### **MERCEDES-BENZ SPRINTER SERVICE SHOP JSP21-20**

Approval of Mercedes-Benz Sprinter Service Shop Preliminary Site Plan at the request of Mercedes-Benz of Novi. The subject property contains 2.31 acres and is located in Section 24, on the west side of Haggerty Road, north of Grand River Avenue. The applicant is proposing to remodel a former body and service facility for the servicing of Mercedes-Benz Sprinter Service Vans.

**PLAN REVIEW CENTER REPORT**  
**Planning Review**  
**Mercedes-Benz Sprinter Service Shop**  
 JSP 21-20  
 September 9, 2021

**SHEET**  
CE3

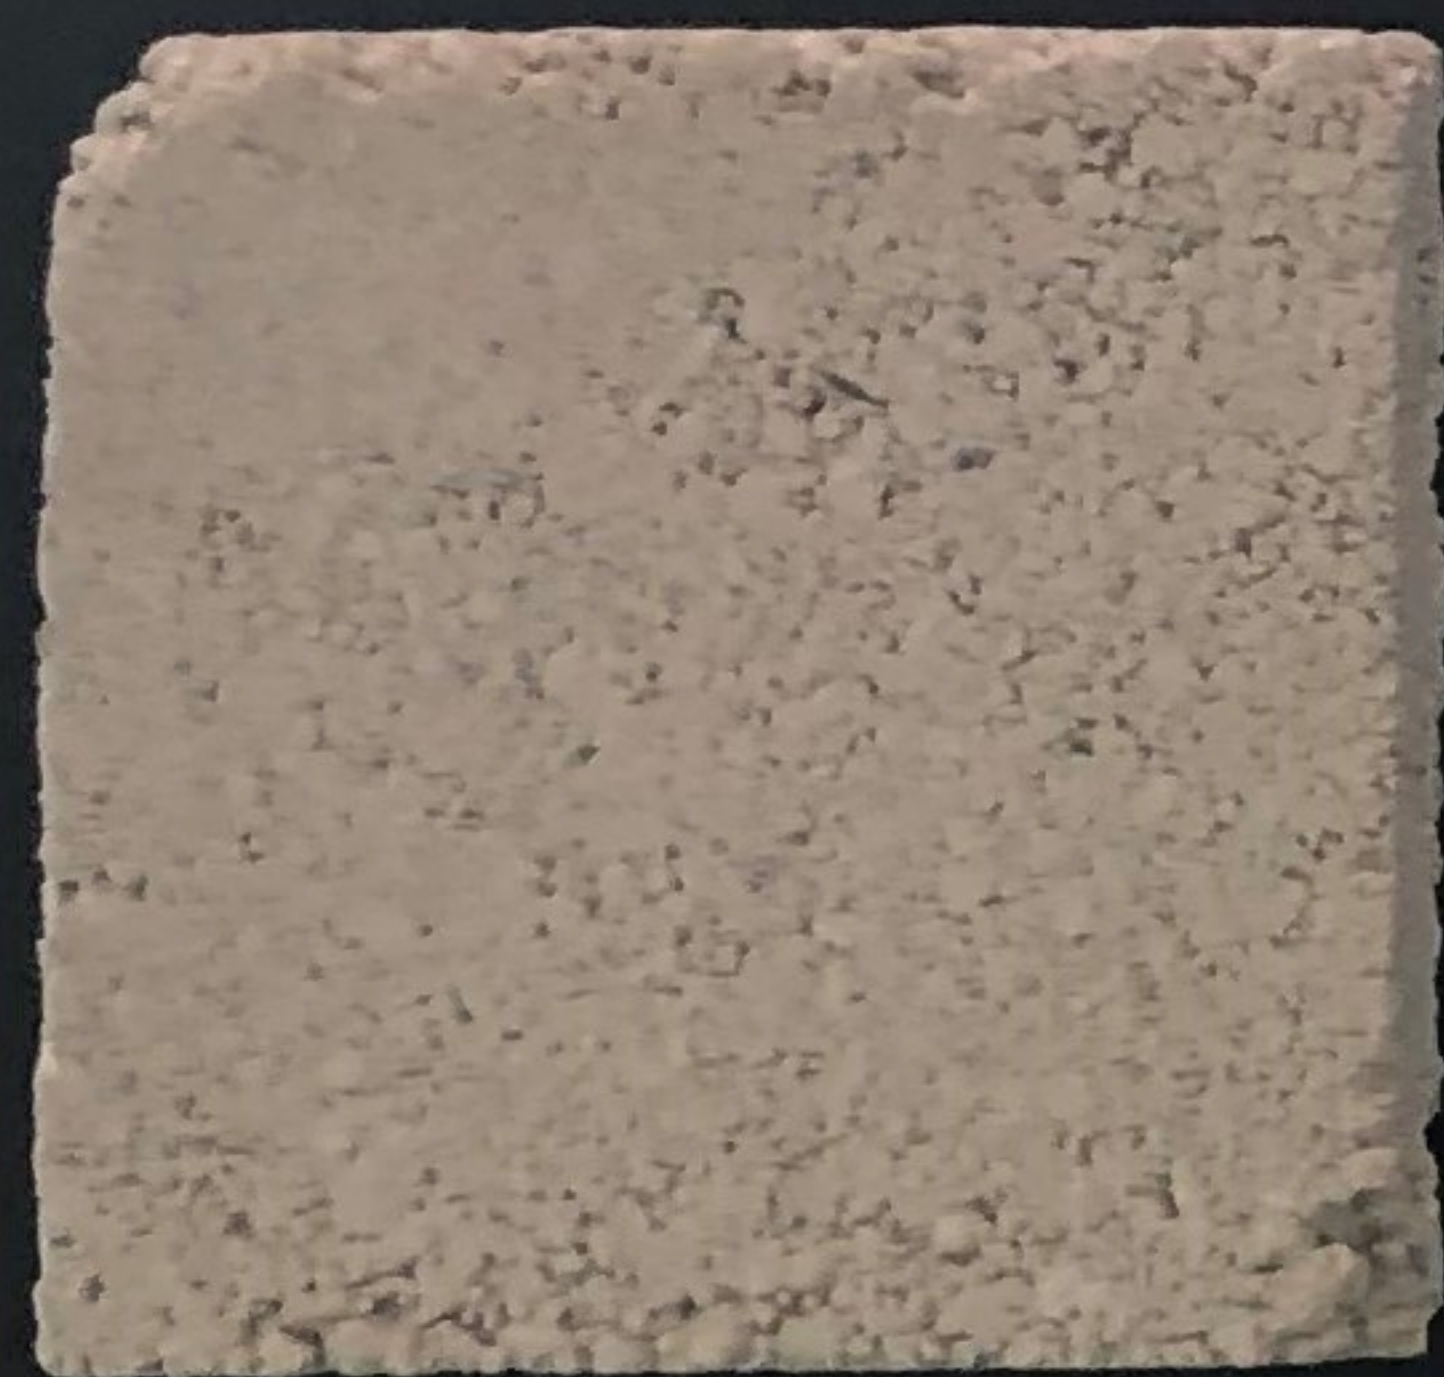
3. Barrier Free Signs: Barrier Free signage has been shown on the site plan. However, a detail sheet has not been provided. **Please provide a signage detail sheet and refer to the Traffic Review for more comments.**

5. Automobile Service Establishment (Sec. 4.50): While the use of the site is not changing, standard notes are still to be provided on the plans. **Please provide the following notes on the site plan:**

7. General Layout: **Please provide the following details on the next submittal:**
  - a. Please show the location of the doors and canopy on the site plan.

- b. Please indicate if any sidewalk is proposed underneath the east canopy.
  - c. Please provide more detail on the staging area in the next response letter.

Barrier Free Signs: Barrier Free signage has been shown on the site plan. However, a detail sheet has not been provided. **Please provide a signage detail sheet and refer to the Traffic Review for more comments.** – Please refer details on sheet CE3 attached with this letter

Please refer additional notation on sheet CE3 attached with this letter.

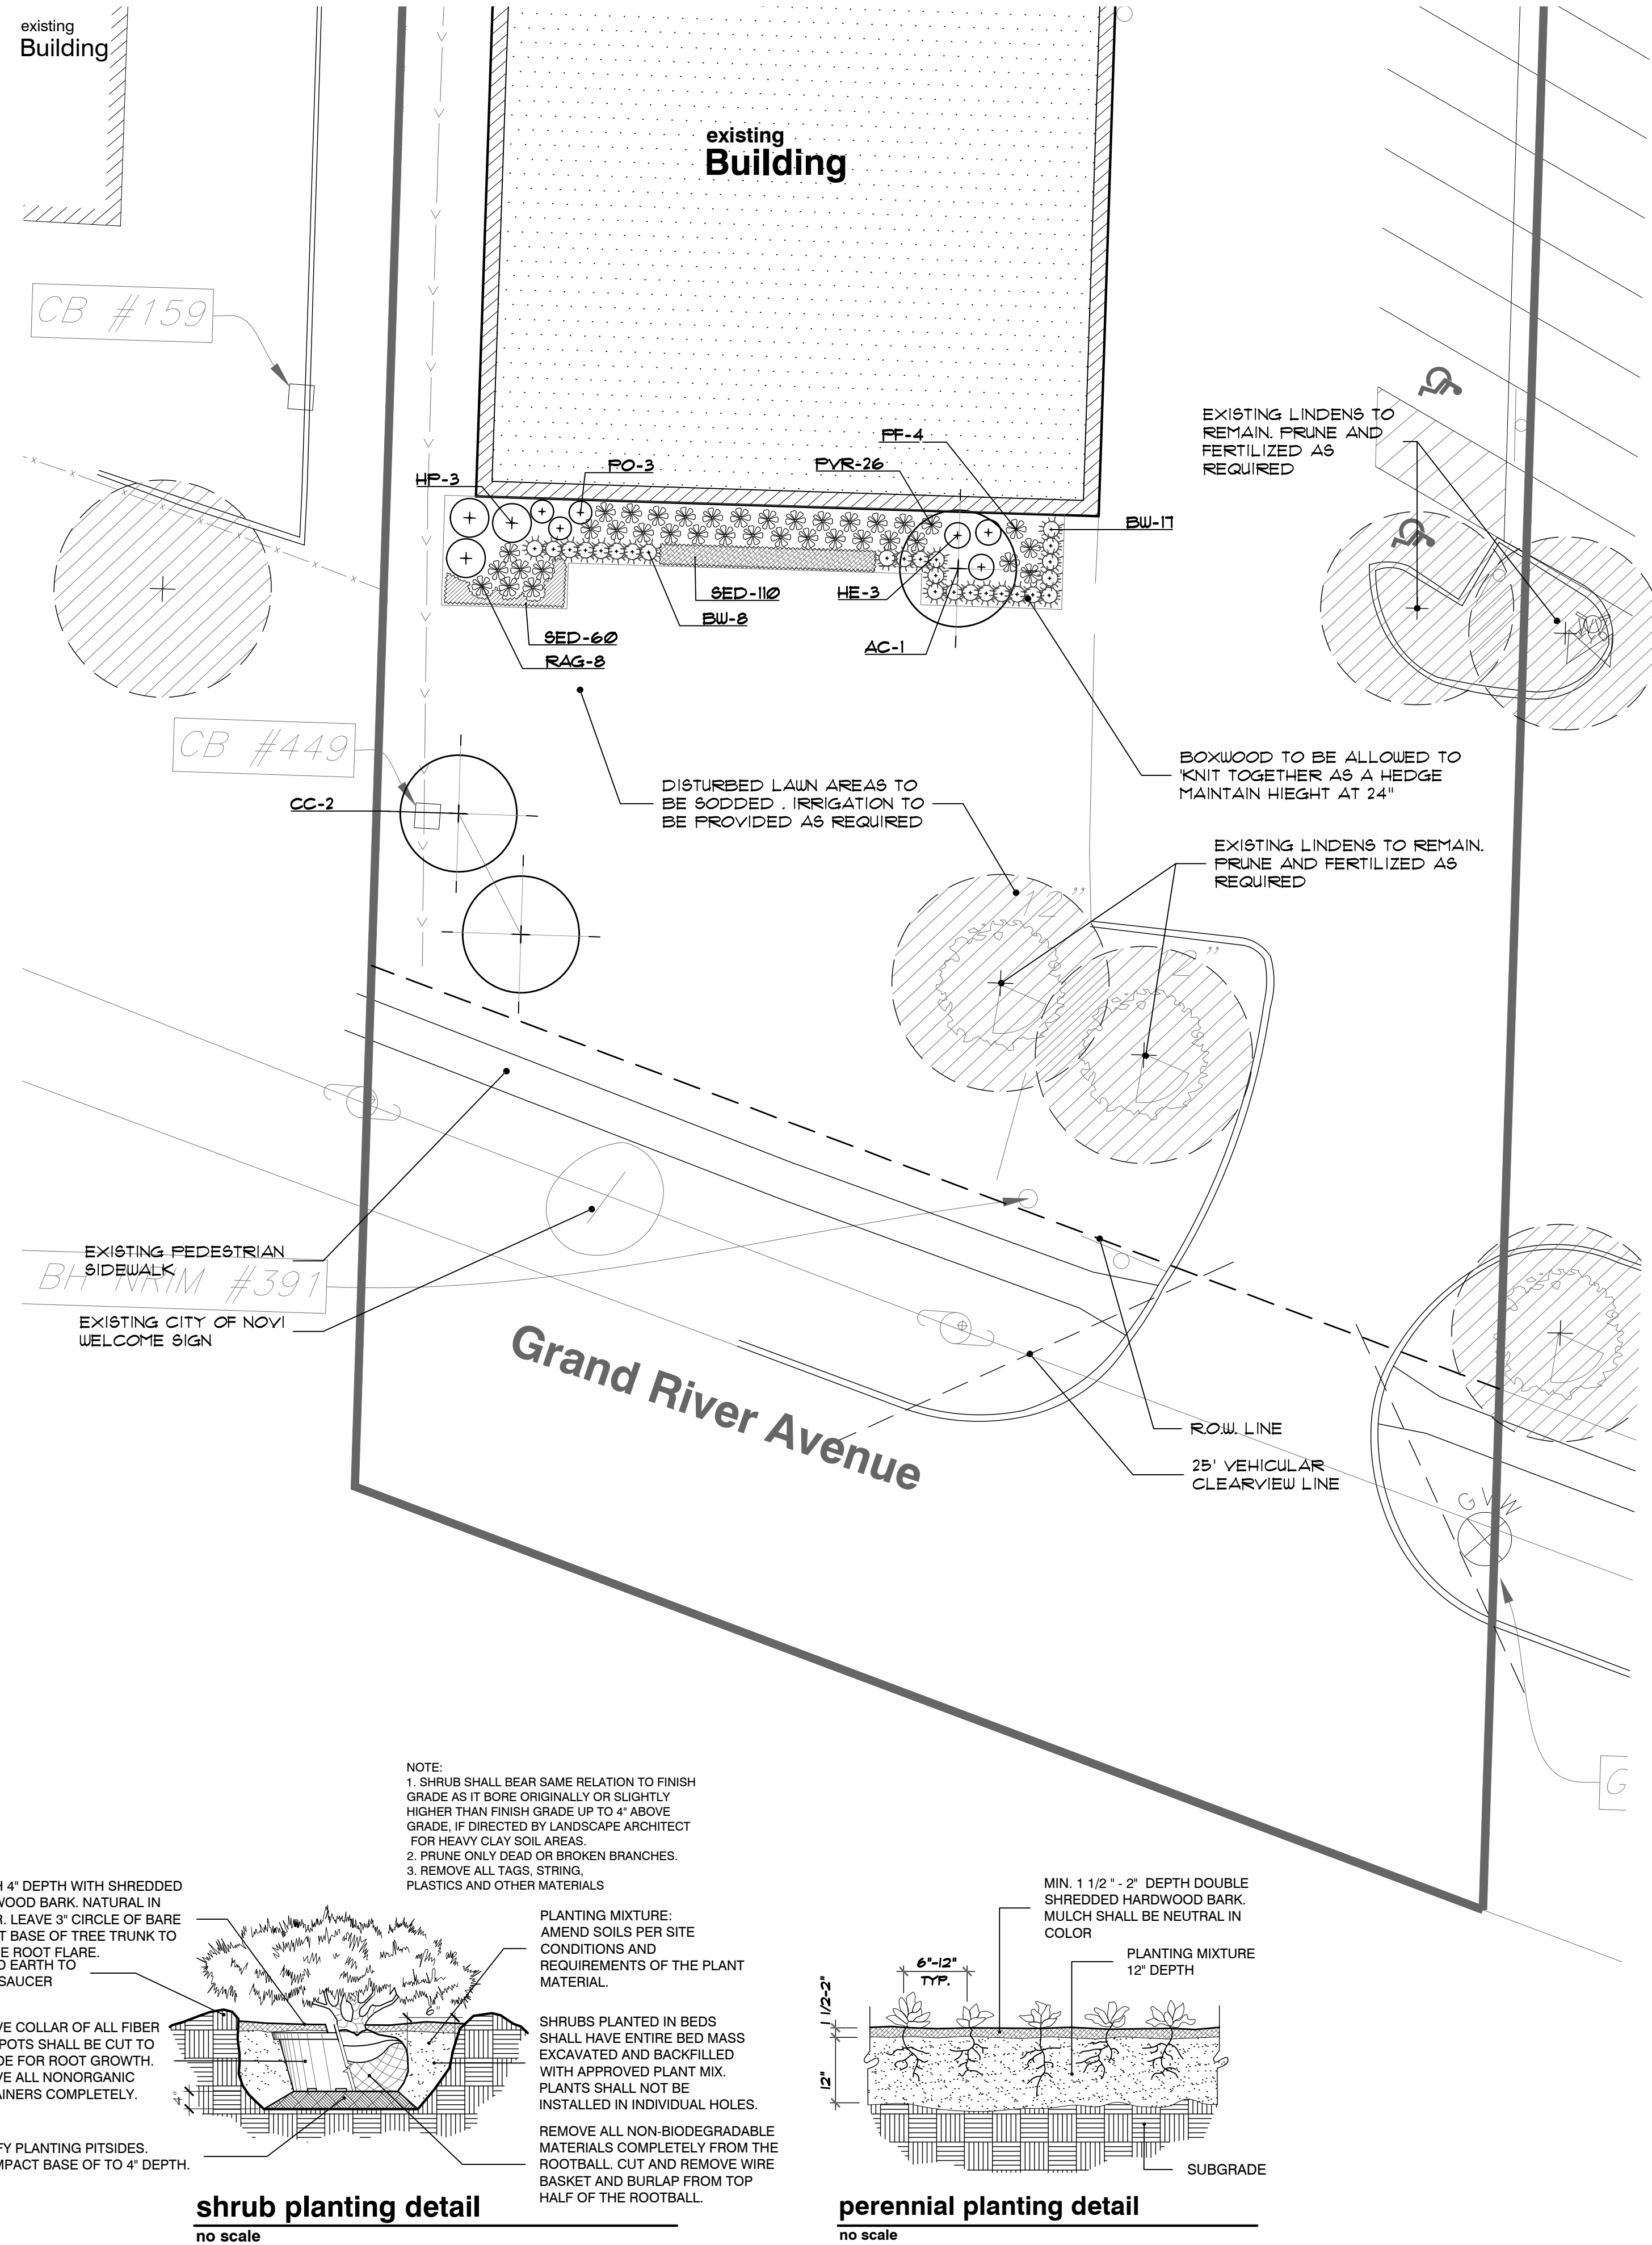
Please show the overhead wires along Grand River and move the redbuds away from them if necessary.

3. Two redbuds in the front yard and a serviceberry near the building have been added, meeting the current greenbelt requirements.
4. **While three street trees are required in the Grand River right-of-way, overhead wires and the Welcome To Novi sign would compete with them, so the applicant is requesting a waiver for those trees.** *The request is supported by staff.*

1. 4 of 10 species used (40%) are native to Michigan (Rozanne Geranium is not native). Please revise the plant list to use species native to Michigan for least 50% of the proposed plantings.
2. The percentage native is a count of the native species divided by total species used. The actual plant counts are not used in the calculation.

1. Required planting details and notes are provided.
2. Please change General Landscape Note #5 to read substitutions shall be approved **in writing.**
3. Please revise Planting Landscape Note#2 to read that replacements should be made within three months, not one year.
4. Please add standard costs for the plants and mulch used in the project and a total cost of the landscape materials (\$375/ornamental tree, \$50/shrub and \$35/cyd for mulch).
